Reference: Engineering Services  
1014 Piney Grove Rawls Rd.  
Knightdale, NC 27545  
TE&D Project No.: 2201-010322\_E

Reference: Engineering Services  
1014 Piney Grove Rawls Rd.  
Knightdale, NC 27545  
TE&D Project No.: 2201-010322\_B

Reference: Engineering Services  
1014 Piney Grove Rawls Rd.  
Knightdale, NC 27545  
TE&D Project No.: 2201-010322\_C-R

**Item 1: Cracked Ceiling Joist**

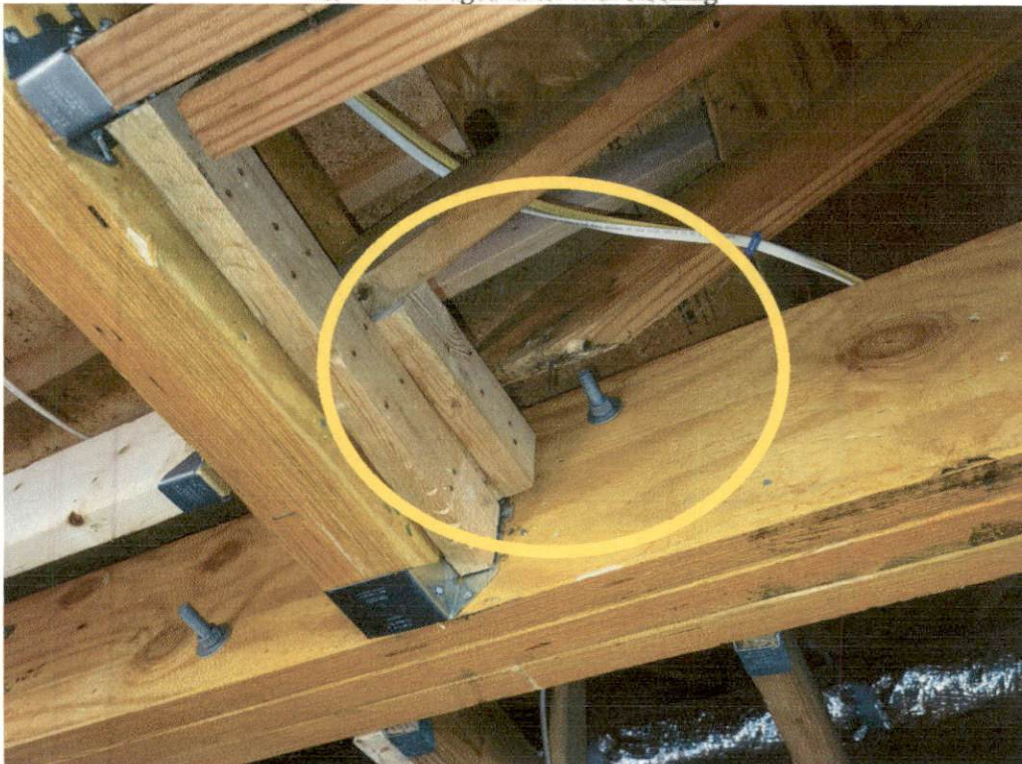
- 1) We observed a crack in a 2 x 6 ceiling joist spanning front to back over the living room. Based on our observations and analysis, a new 2 x 6 joist is to be "sistered" to the cracked joist with (2) rows of 10D nails at 16" o.c. The new joist is to have full bearing at each end.

Framing detail for Walls to be Removed  
(Cut from Plans Sealed on 9/26/2023)  
(Not to Scale)

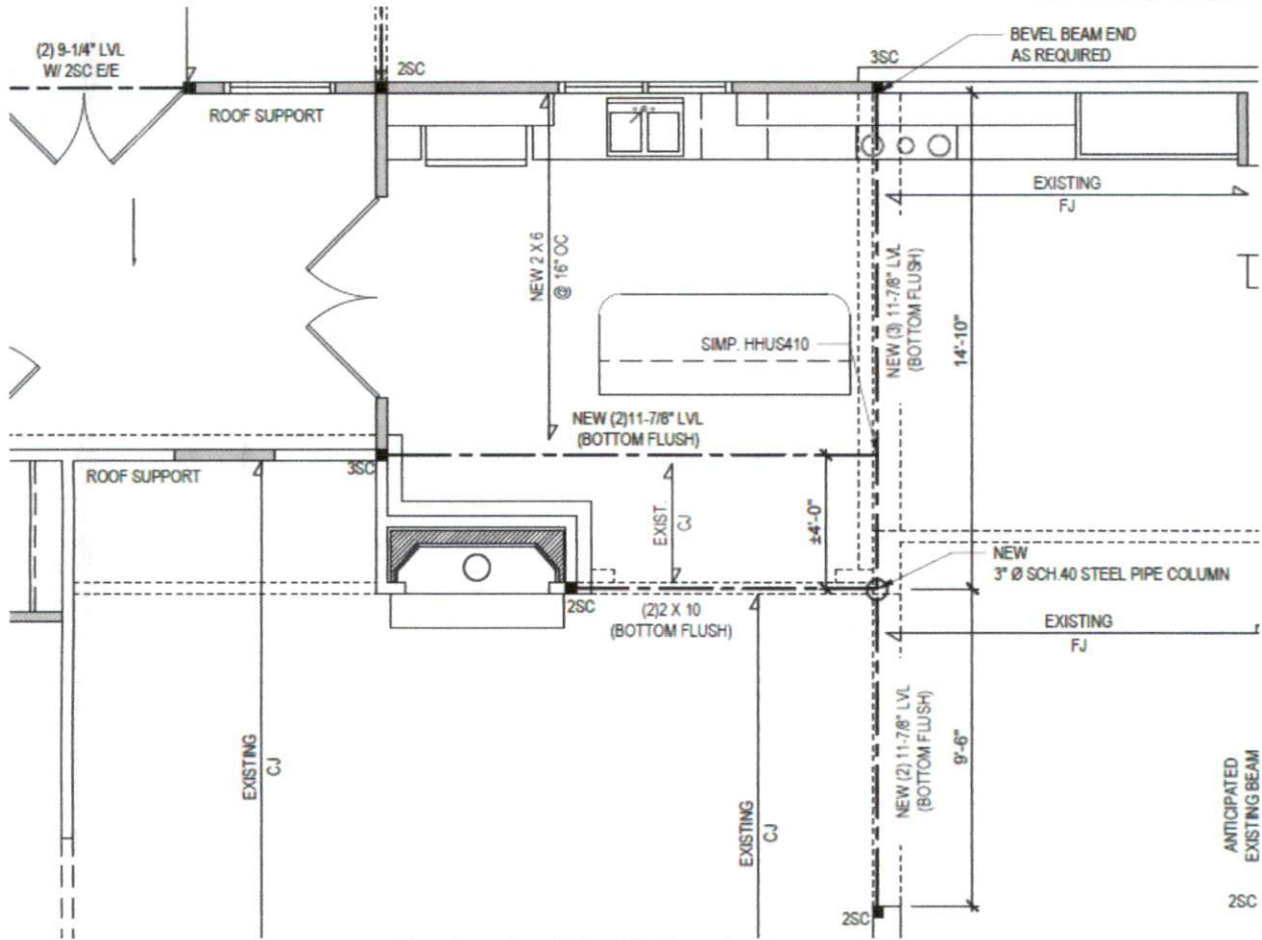
- 1) Based on our observations and analysis, the new opening is to be framed per the detail included in the plans sealed on 9/26/2023.
- 2) Based on our observations and analysis, the new opening is to be framed per the detail included in the plans sealed on 9/26/2023.
- 3) Based on our observations and analysis, the new opening is to be framed per the detail included in the plans sealed on 9/26/2023.
- 4) Based on our observations and analysis, the new opening is to be framed per the detail included in the plans sealed on 9/26/2023.
- 5) We understand the 2 x 10 floor joists below the rear addition are to be notched in order to be secured to the 2 x 8 band. Based on our observations and analysis, the floor joists may be notched to achieve the required support for the anticipated loading conditions.

Framing detail for Walls to be Removed  
(Cut from Plans Sealed on 9/26/2023)  
(Not to Scale)

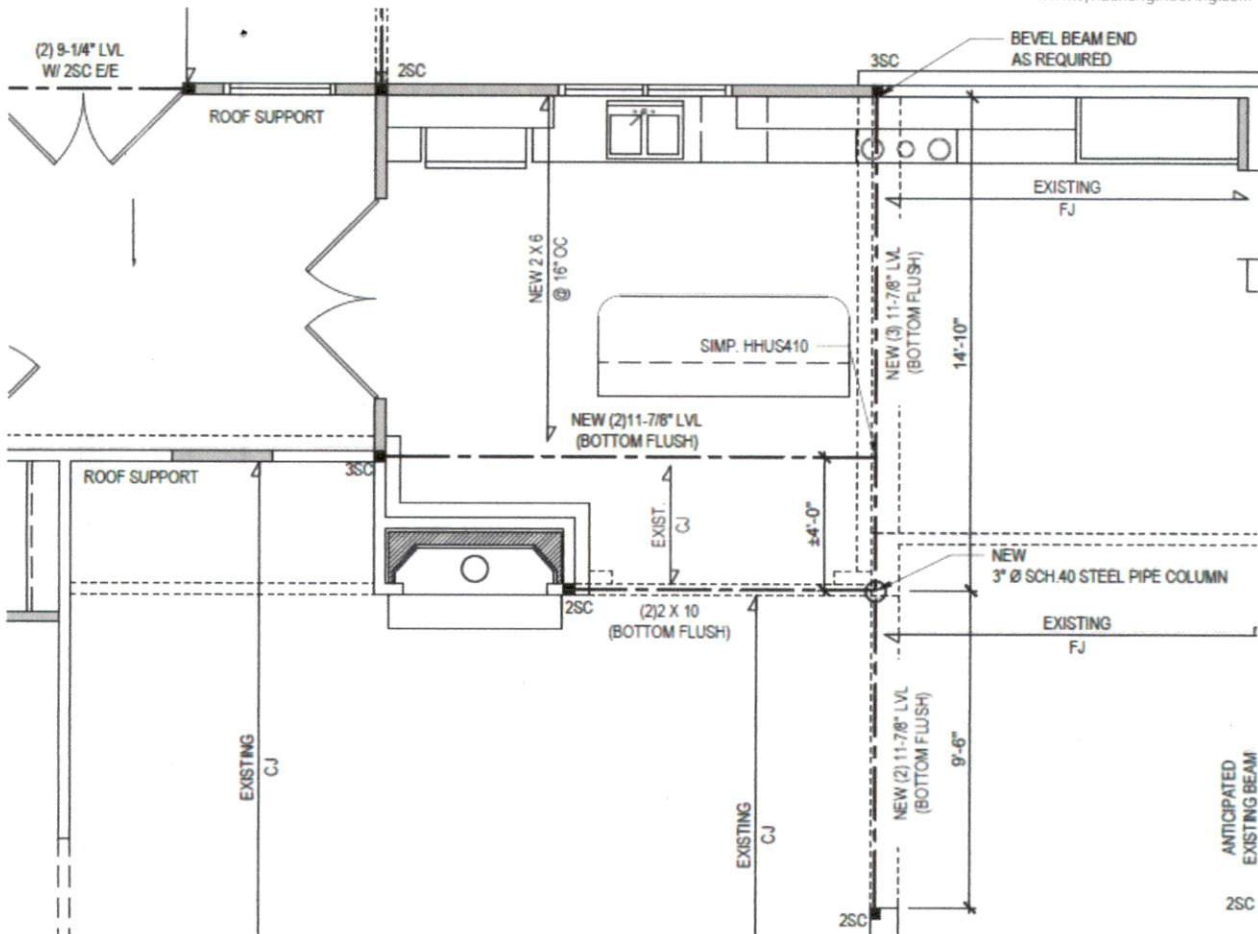
- 1) Based on our observations and analysis, the new opening is to be framed per the detail included in the plans sealed on 9/26/2023.
- 2) Based on our observations and analysis, the new opening is to be framed per the detail included in the plans sealed on 9/26/2023.
- 3) Based on our observations and analysis, the new opening is to be framed per the detail included in the plans sealed on 9/26/2023.
- 4) Based on our observations and analysis, the new opening is to be framed per the detail included in the plans sealed on 9/26/2023.
- 5) We understand the 2 x 10 floor joists below the rear addition are to be notched in order to be secured to the 2 x 8 band. Based on our observations and analysis, the floor joists may be notched to achieve the required support for the anticipated loading conditions.
